City of West Allis

Plan Commission

Wednesday, October 22, 2025

**PLAN COMMISSION STAFF REPORT
WEDNESDAY, 10-22-25 @ 6PM
WEST ALLIS CITY HALL, ROOM 128
7525 W. GREENFIELD AVE.**

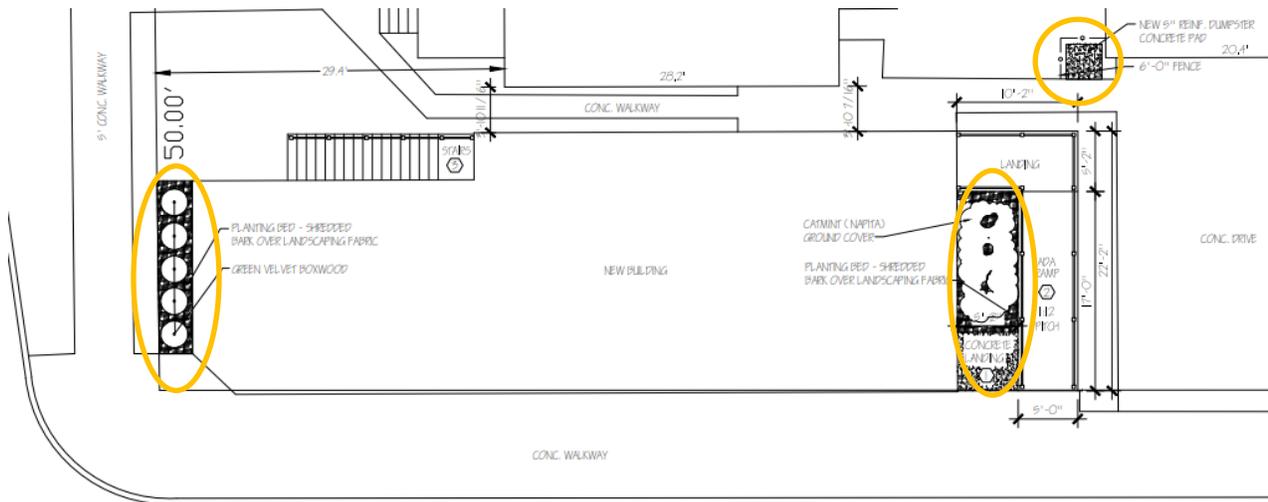
A new dumpster, concrete pad, and fenced enclosure are indicated in the landscaping plan to the northeastern corner of the project area. The dumpster is screened with a 6-foot fence, though the construction materials for this enclosure are not detailed in the plans. Presently, parking for this building will be offered along Becher St. and S. 79th St. with the existing concrete walkways remaining unchanged. No lighting plans have been submitted as part of the greater landscaping plan for this project.

1. A revised site, landscaping, and architectural plan being submitted to the City Planning Office to show the following: (a) exterior material color and finishes shown on the architectural plans; (b) confirmation of the refuse area and enclosure details.
2. An exterior site lighting plan for the overall properties being provided to identify existing and proposed exterior lighting. Fixture details being provided.
3. Submit a signage plan for design review and permitting.

1 PROPOSED SITE MODIFICATIONS PLAN
F4 SCALE: 1" = 20'-0"

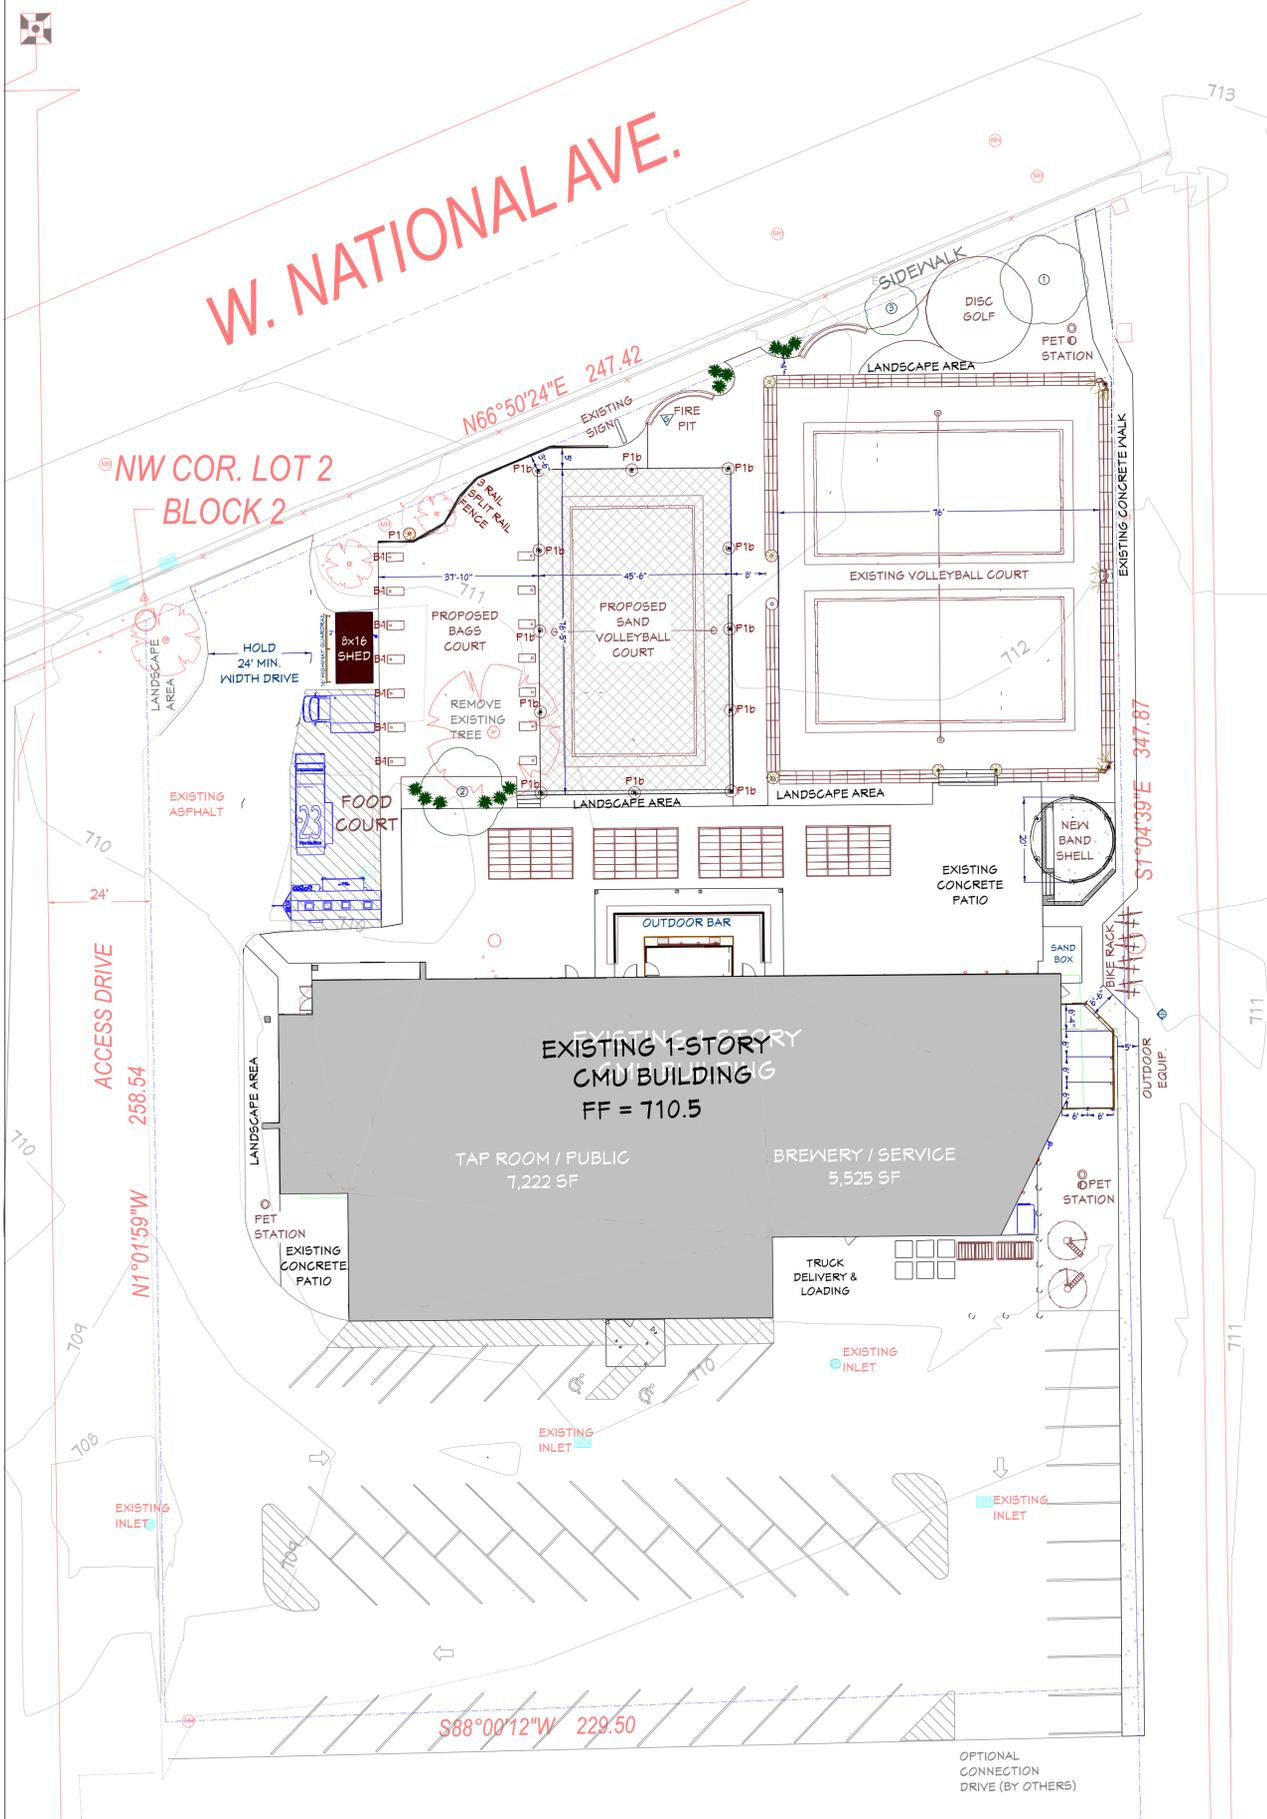
Our primary objective is to add a third volleyball court. To accommodate this, we will remove the existing bocce court and a cottonwood tree. We will also shift the existing cornhole courts to the west, increasing them from five to seven lanes.

Additionally, we plan to enhance the site with new plantings, trees, split-rail fencing, and a storage shed for sports equipment. We are designating additional food truck parking spaces, aligning with our current practice of hosting two to three food trucks out front.
